ÁS	TECHNICAL	Product:	Document #:	Rev:	Page:
EAKEEPER	BULLETIN	MODEL 7000A GYRO	90062	1	1 of 7

<u>Description:</u> Technical Differences Between Model 7000A and Model 7000 Gyros

Wiring Diagram for Alarm and Seawater Pump Control Outputs

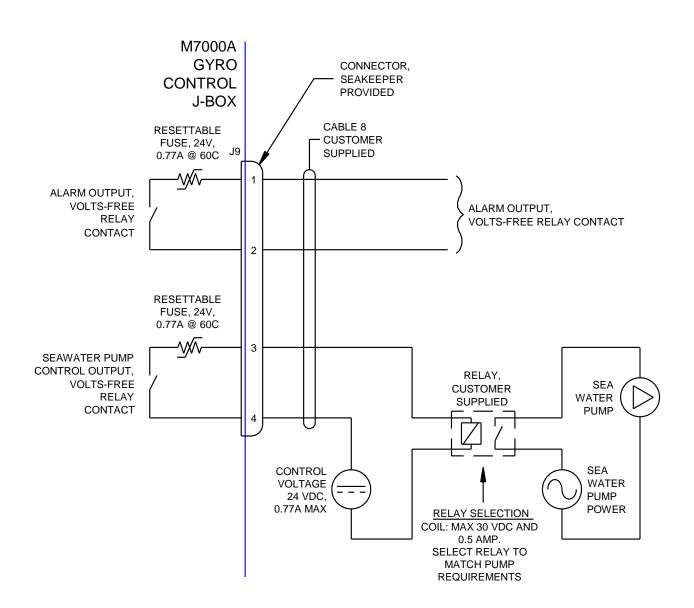
- This cable is provided by Seakeeper
- 1 New cable for customer to supply.
 - CABLE 8, volts-free relay contact for Alarm and Seawater Pump Control is customer supplied.

- \circ 4 x 22AWG (or 4 x 0.3mm²)
- 2 New connectors for customer to assemble.
 - o 24 VDC power input on CABLE 1.
 - Allows customer connection of 24 VDC without opening the Gyro Control J-Box enclosure.

- Alarm and Seawater Pump Control outputs on CABLE 8.
 - Allows customer connection of volts-free relay contact without opening the Gyro Control J-Box enclosure.

- New features:
 - Alarm output (volts-free relay contact) see wiring diagram on the next page
 - Alarm contacts open when any Alarm condition is detected by the Gyro Controller. Alarms also cause the Gyro precession to stop (LOCK mode) and the flywheel to begin spooling down (STOP mode).

- Seawater pump control output (volts-free relay contact) see wiring diagram on the next page
 - Contacts close when motor is started (RUN mode) and remain closed until motor is spooled down (STOP mode) below 5000 RPM provided pump power is left on.
